**RE: Legacy Uptown Apartments
Grading and Drainage Plan
Engineer's Stamp Date: 09/05/18
Hydrology File: J18D033**

Based upon the information provided in your submittal received 09/06/18, the Grading and Drainage Plan **is not** approved for action by the DRB for Site Plan for Building Permit. The following comments need to be addressed for approval of the above referenced project:

PROJECT NAME:	MARKANA UPTOWN AMERICAS PARKWAY NE ALBUQUERQUE, NEW MEXICO
SHEET TITLE:	CONCEPTUAL DRAINAGE PLAN
ISSUED FOR:	SITE PLAN FOR BUILDING PERMIT
SHEET NUMBER:	C-1

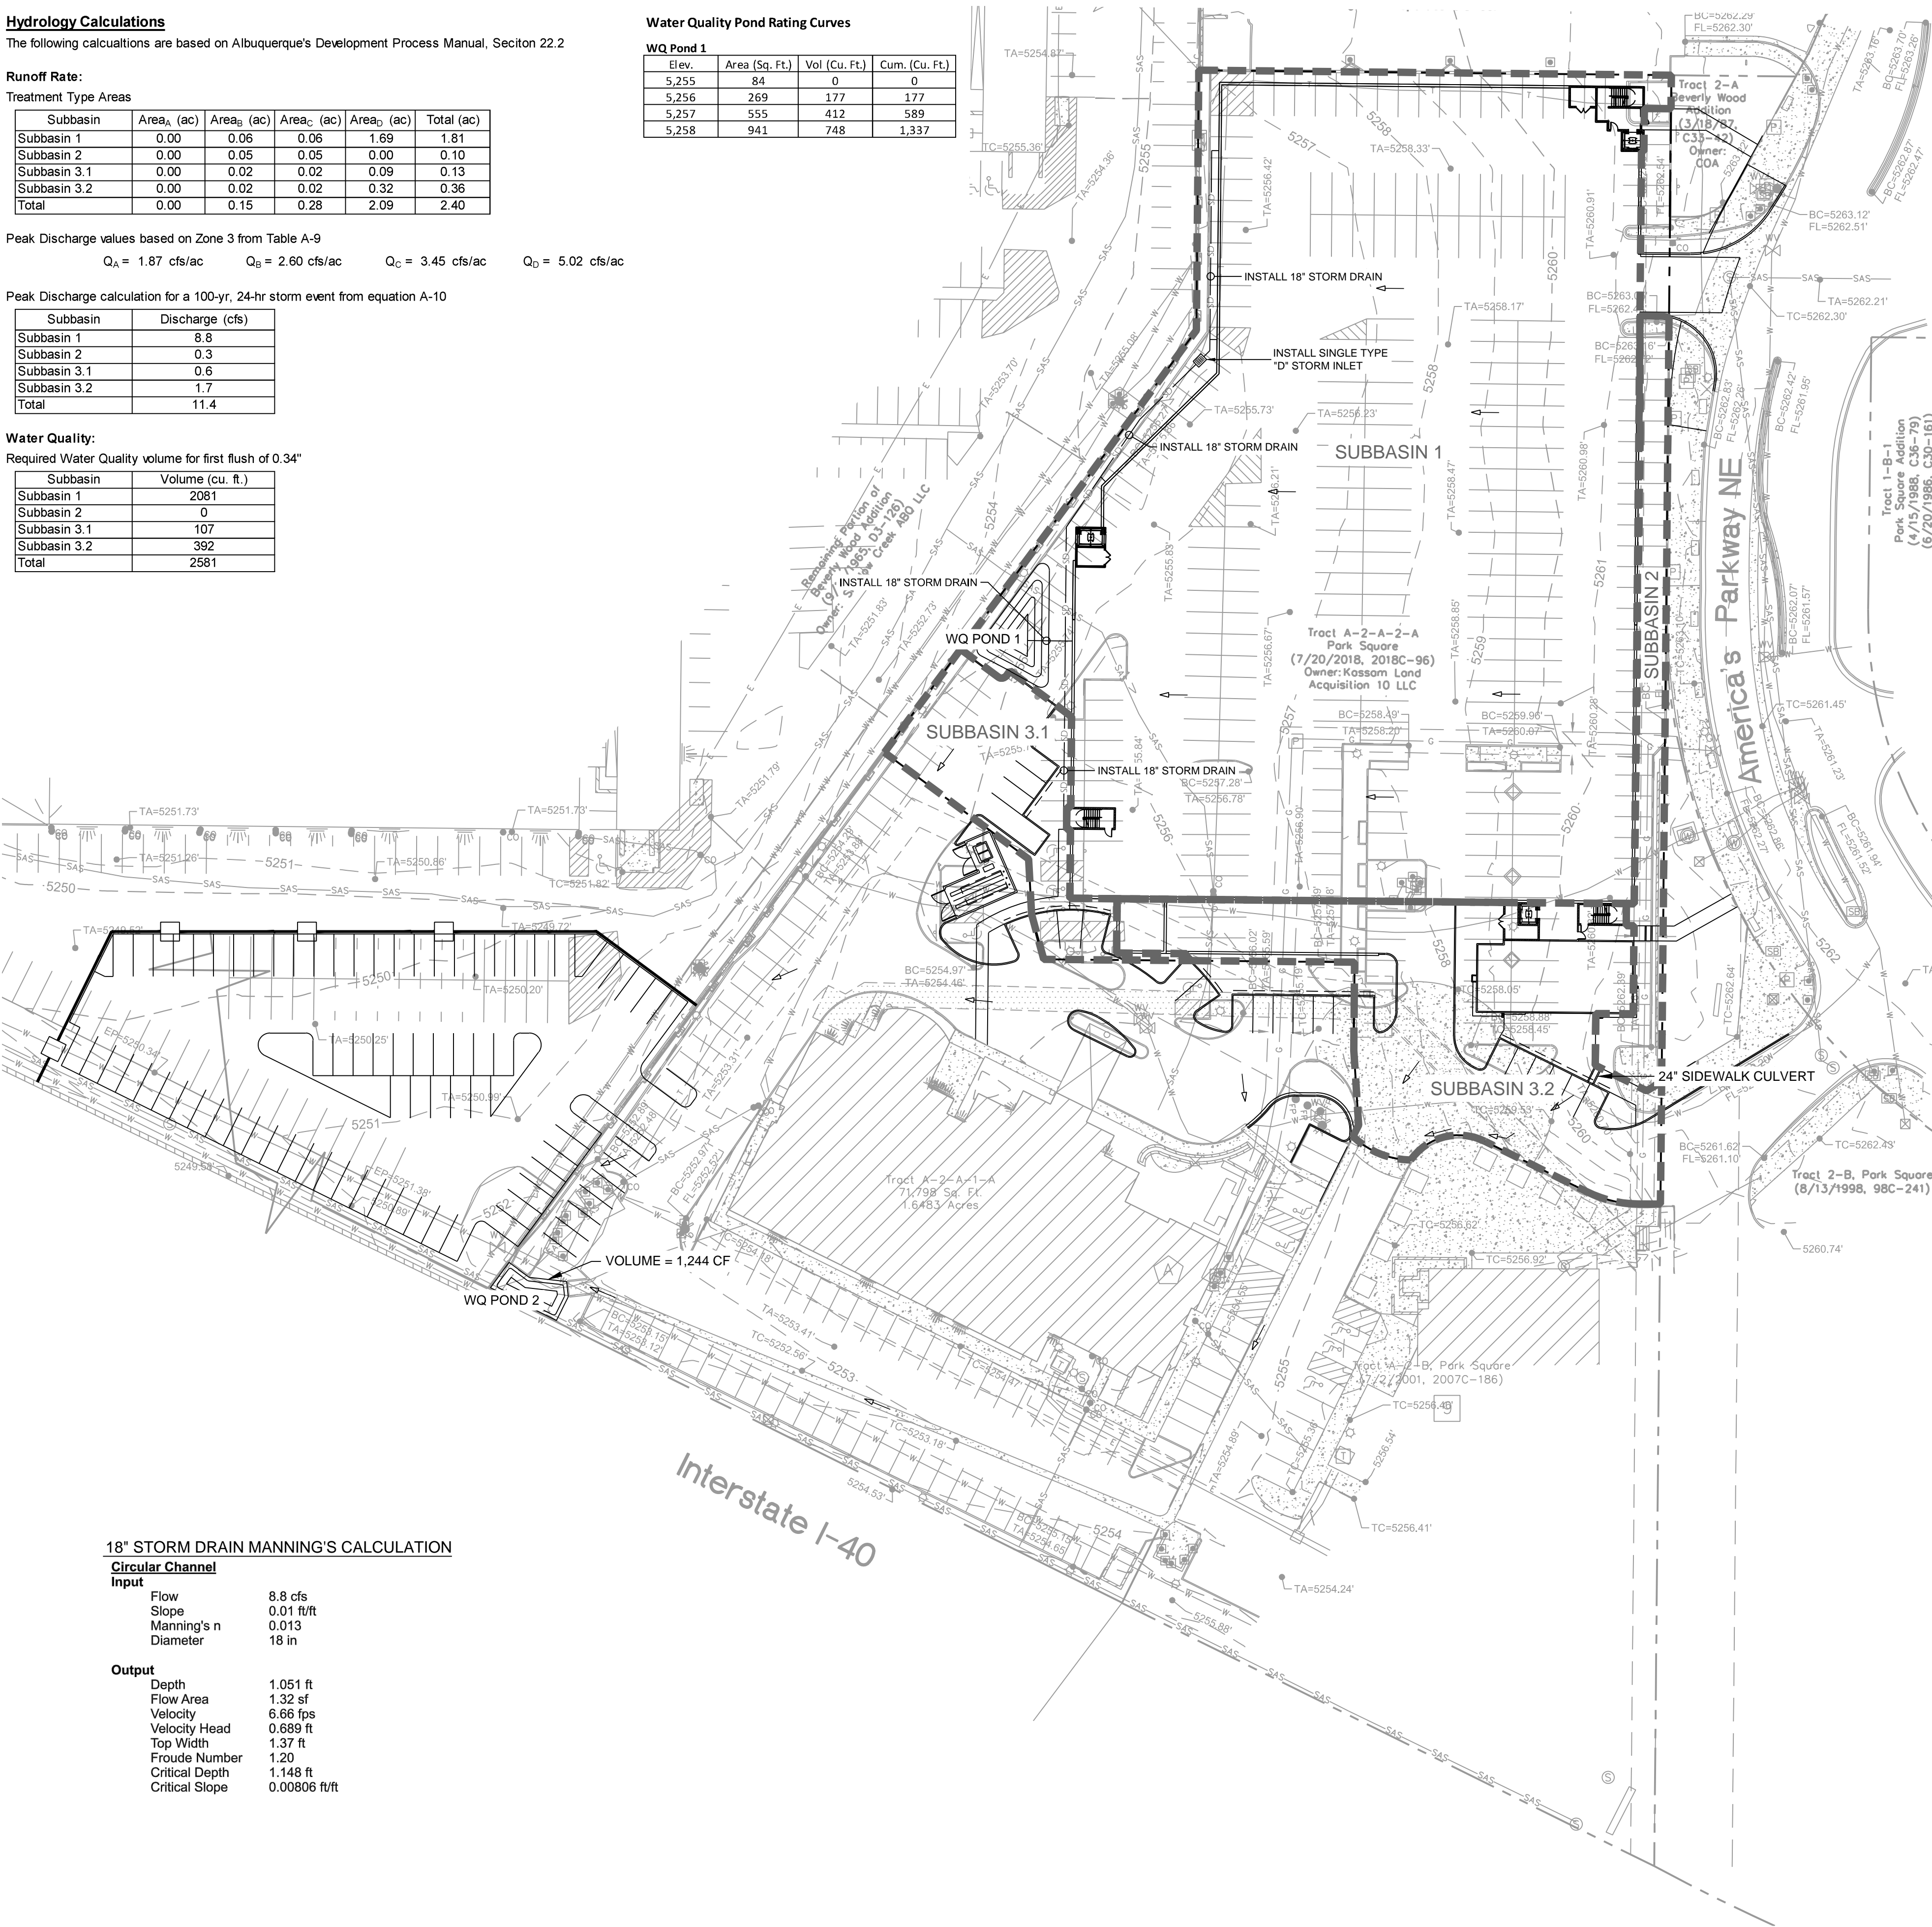
1. Please provide the benchmark information for the survey contour information provided.
2. Please add the effective date of the FIRM Map.
3. Please label the other sidewalk culvert on Sheet C-1.
4. Please label the construction fence and the temporary parking on the adjacent apartment property Sheet C-1.
5. Please make the off-site temporary parking as a separate basin on Sheet C-1. Please state that the area will be restored to pre-construction conditions if that is what is going to be done. If this will not happen, then a first flush pond for the newly added parking area will need to be identified.
6. For Sheet C-2 only, please remove the existing survey information that will be demolished and replaced by this project. Also please provide a light hatch pattern for the proposed sidewalk. This will help in the review process to determine what is being proposed and what is staying.
